## *City of El Paso – City Plan Commission Staff Report*

**Case No:** SUSU15-00050 Gateway Stormwater South Pond  
**Application Type:** Resubdivision Combination  
**CPC Hearing Date:** September 24, 2015  
**Staff Planner:** Joaquin Rodriguez, (915) 212-1608  
[rodriguezjx3@elpasotexas.gov](mailto:rodriguezjx3@elpasotexas.gov)  
**Location:** South of Interstate 10 and West of Copia  
**Acreage:** 4.071 acres  
**Rep District:** 8  
**Existing Use:** Vacant and Residential  
**Existing Zoning:** M-1 (Manufacturing), C-4 (Commercial)  
**Proposed Zoning:** M-1 (Manufacturing), C-4 (Commercial)  
**Nearest Park:** Mary Webb Park (.25 Miles)  
**Nearest School:** Beall Elementary (.5 Miles)  
**Park Fees Required:** N/A  
**Impact Fee Area:** N/A  
**Property Owner:** El Paso Water Utilities  
**Applicant:** El Paso Water Utilities  
**Representative:** Conde Inc.

## ATTACHMENT 3

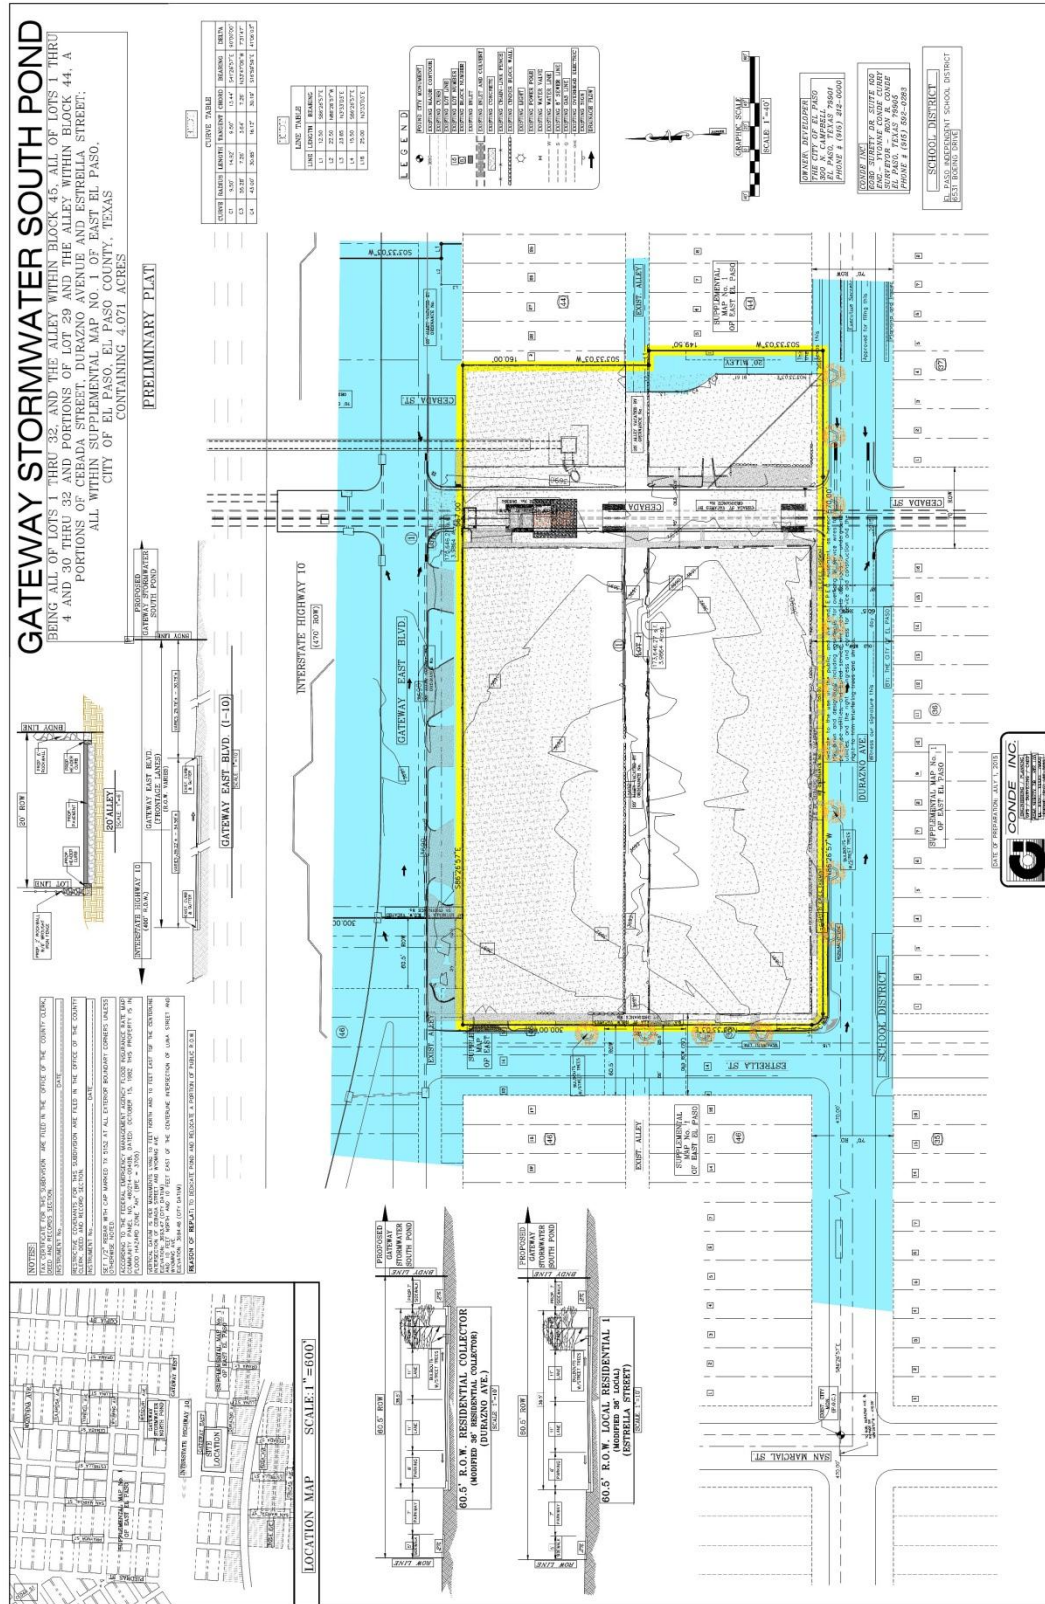
1. Add the alley on the dedication statement.
2. On the Preliminary Plat, the Drainage Report indicates the wrong Federal Emergency Management Agency (FEMA) Flood Insurance Rate Maps. (FIRM) Panel Number (example 480212-0044C).
3. Check for any overlapping text on Cebada St. and alley labels.
